Product Modification Notice

WW2000, January 2020

Pluggable fuse holder and Component holder Modification – SIHA 3/LD & BEST

SIHA 3/LD Fuse Holder Change

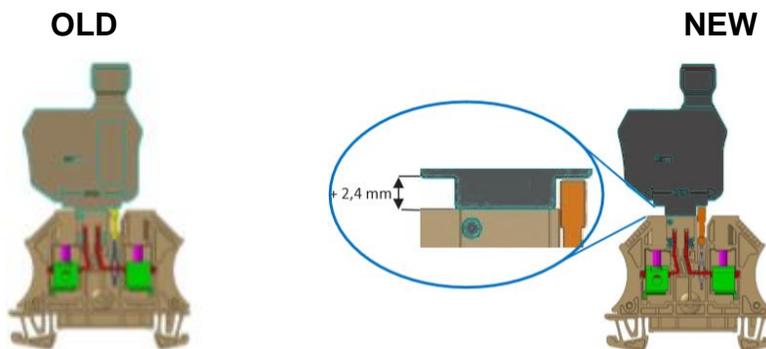
- 1.) Base of fuse holder has been raised to give clearance for a taller pluggable jumper which is currently used in our Push-In series of terminals.
- 2.) Color change to black for LED versions **Only!**

Note: All non-indicating SIHA 3 plug versions will remain beige in color.

BEST, BEST LD & BEST DRBR Component Holder Change

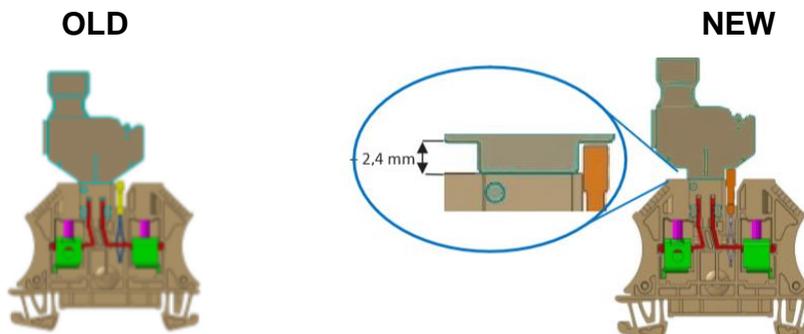
- 1.) Base of component holder has been raised to give clearance for a taller pluggable jumper which is currently used in our Push-In series of terminals.
- 2.) No color change to the component holder

Note: Soon we will consolidate to one pluggable jumper (Orange – Push-in Series version) to become the standard for screw clamp, tension clamp and push-in terminal technology. Thus, the modification on these holders.
